UNITED STATES PATENT AND TRADEMARK OFFICE

10/750,341

Office Action Summary	Application No.	Applicant(s)	
	10/750,341	HITZENBERGER, CHRISTOPH K.	
	Examiner	Art Unit	
	Samuel A. Turner	2877

DETAILED ACTION

FIGURE 3

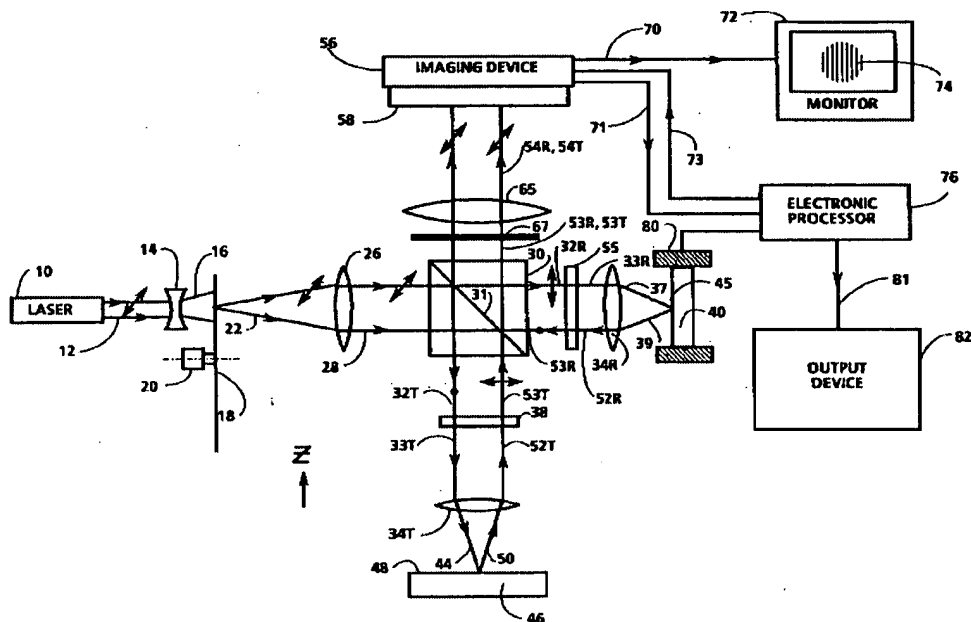
With regard to claim 1, Biegen teaches a interference surface profiler system comprising:

an interferometer (figure 3) having a reference arm (45, 55) and a sample arm (38, 48) each having an optical path, the sample arm being disposed such that a test sample (46) reflects a sample portion $R_s(52T)$ of an incident optical signal $S_s(33T)$ along the sample arm optical path;

a reflector (45) disposed in the reference arm to reflect a reference portion $R_R(52R)$ of an incident optical signal $S_R(33R)$ along the reference arm optical path;

a source (10, 18) for producing an optical source signal $S(28)$ having a short coherence length (column 4, line 68) and a first polarization state;

a polarizing beam splitter(30) disposed to direct portions of the optical source signal S along the reference arm optical path and the sample arm optical path;

a first polarizing element(67) disposed to select, from the returning reference and sample portions (R_R+R_S), a detector component $S_D(54R,54T)$ having a second polarization state; and

a detector(58) disposed to produce an output signal V_D representing the optical signal intensity I_D of the detector component S_D , wherein the second polarization state is related to the first polarization state such that the detector operates in a noise-optimized regime.

As to claim 10, wherein the interferometer is a Michelson interferometer(**figure 3**).

a second polarizing element(38) disposed in the sample arm optical path such that the returning sample portion R_S is directed by the polarizing beam splitter to the detector.

a second polarizing element(55) disposed in the reference arm optical path such that the returning reference portion R_R is directed by the polarizing beam splitter to the detector.

in the detector, a plurality of optical transducers(56) each disposed to produce an electrical signal responsive to the detector component S_D .

As to claim 15 wherein the second polarization state is related to the first polarization state(54R,54T) such that the detector operates in a shot-noise limited regime.

FIG. 1A

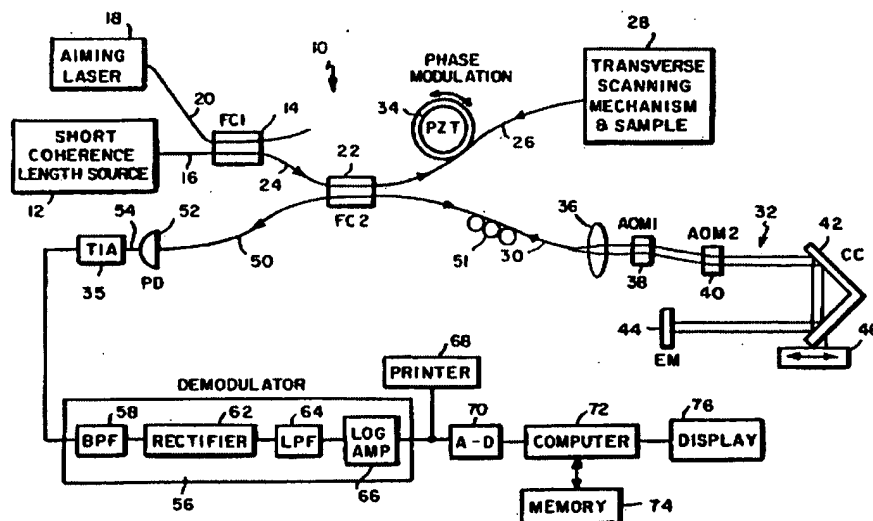
As to claims 9 and 25, Biegen teaches moving the reflector along the reference arm optical path by (column 8, lines 31-36) a reflector motor (80) disposed to move the reflector (45) along the reference arm optical path. Biegen however fails to teach any form of surface scanning.

Swanson teaches a transverse scanning mechanism 28 positioned in the measurement arm in order to scan the entire area of interest.

It would have been obvious to one of ordinary skill in the art at the time the invention was made to modify the apparatus of Biegen by including a transverse scanning mechanism either in the measurement arm or in the stage which holds the sample in order to profile samples larger than the image size of the interferometer.
